**MAJOR PROJECT ASSESSMENT:
Homebush Bay Bridge
Homebush Bay, between Wentworth
Point and Rhodes
(MP10_0192)**

Director-General's
Environmental Assessment Report
Section 75I of the
Environmental Planning and Assessment Act 1979

March 2013

Figure 7 Pedestrian rest areas (Source: Response to submissions 2012)

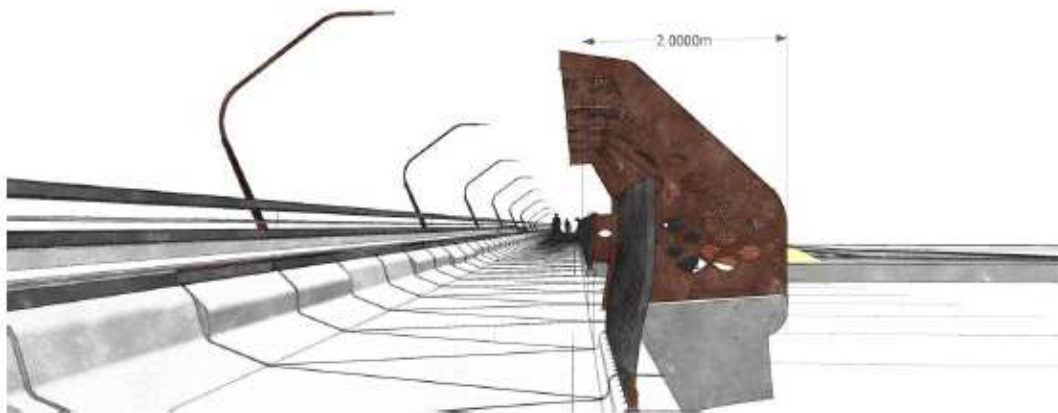
The department notes that RMS has emphasised the need to provide appropriate shoulder width along the shared path and bus lane. The department considers that the proponent has generally maximised the width of the shared path for use by cyclists and pedestrians, by committing to separating the proposed rest areas from the shared path. This would include installation of the rest areas as overhangs from the bridge deck (see **Figure 7**). The department considers that the proposed deck configuration, including the width of the bus lanes and shared path, is appropriate for the intended use of the bridge, particularly given the proposed shared path would meet minimum widths for recreational and commuter paths under the *Guide to Road Design Part 6A: Pedestrian and Cyclist Paths*.

Figure 8 Rhodes peninsula foreshore public domain - indicative plan (Source: EA 2012)

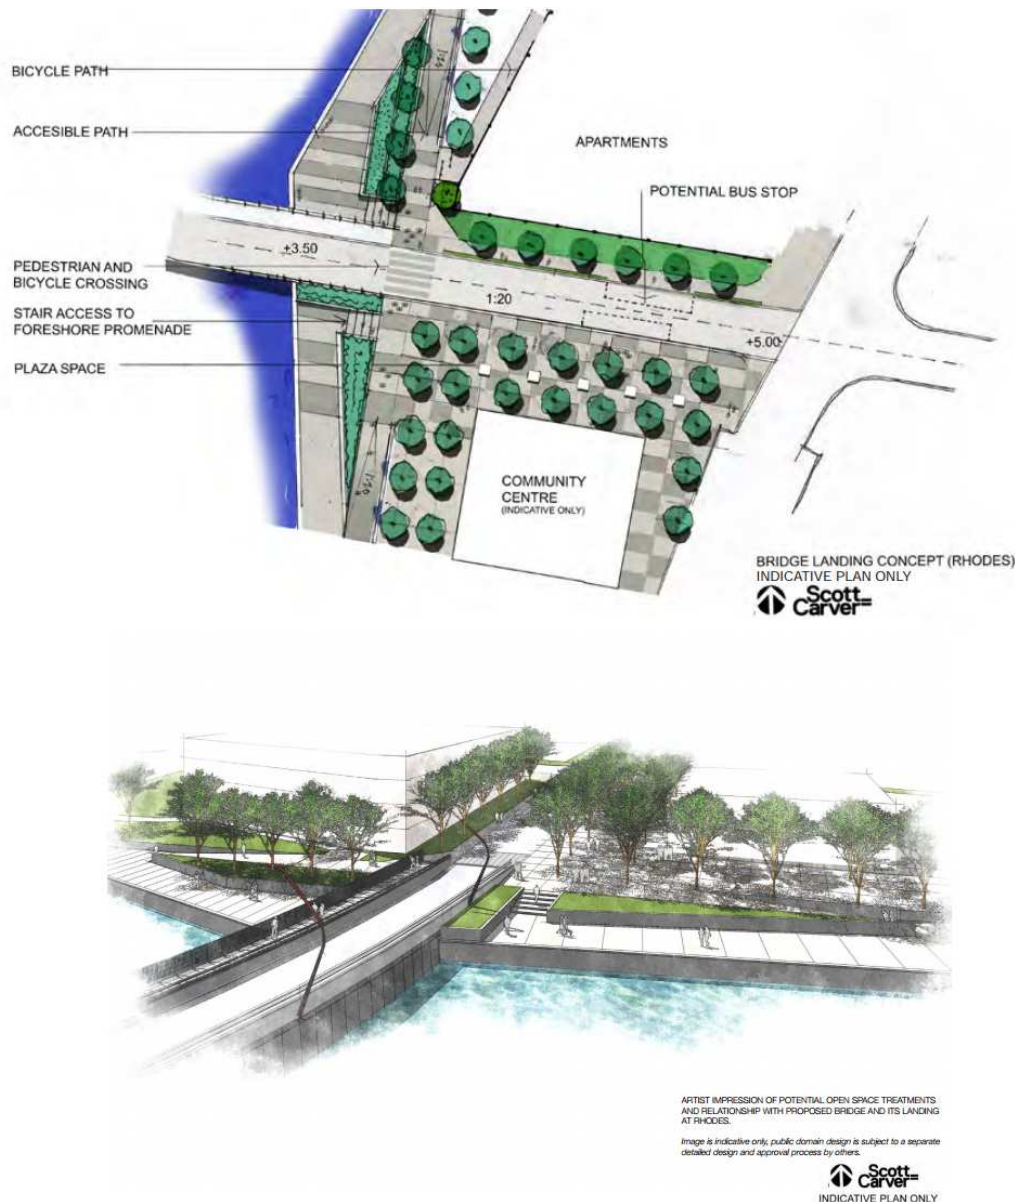
The indicative plans for the bridge approaches at Rhodes and Wentworth Point provide an appropriate general indication of the interface between the bridge and the Homebush Bay foreshore. The department, however, acknowledges that while the detailed design of the bridge is to be determined, there remains a need to ensure that the bridge is designed in a manner appropriate for the local area. In particular, the department acknowledges City of

Canada Bay Council's concerns, raised following review of the RtS, regarding integration of the bridge approach with the Rhodes Community Precinct on Shoreline Drive and Gauthorpe Street. In response, the department has recommended a number of conditions to provide additional certainty prior to construction regarding the final built form of the bridge and its integration with the existing and proposed landscape. The department has recommended a condition requiring the proponent to prepare an urban design and landscape plan for the proposal, in conjunction with agencies including Auburn City Council, City of Canada Bay Council and RMS. The plan would provide an integrated urban design outcome by detailing proposed landscaping, external materials and finishes, and public art in accordance with the *City of Canada Bay — Public Art Strategy 2008-2013*. The department has additionally recommended a condition that would require the proponent to prepare a lighting plan for the proposal. Further, the department has recommended a condition requiring provision of access for people with disabilities. The department considers that these conditions would provide for appropriate integration between the bridge and its surrounds. Further, the department notes that City of Canada Bay Council supports the recommended conditions of approval.

Figure 11 Representative operational noise receivers (Source: EA 2012)

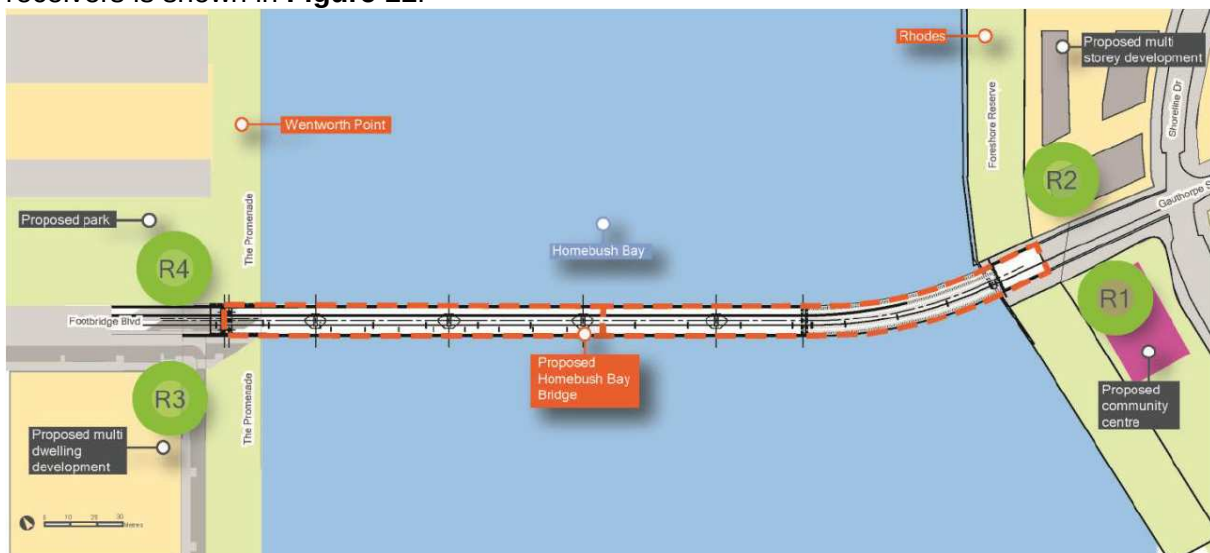
The department acknowledges that noise impacts would exceed noise criteria for short periods during AM and PM peaks. To minimise the noise impacts of the proposal, the department has recommended a condition requiring the proponent to provide details of measures to monitor and manage noise impacts as part of the operational environmental management plan. This would include a requirement that the proponent undertake an operational noise report, including noise monitoring once operation of the bridge commences to verify the accuracy of the modelling, and a review of the appropriateness of mitigation measures. Should the proponent identify that the proposed mitigation measures would not provide appropriate reduction of operational noise impacts, the department will require details of any additional proposed noise mitigation.
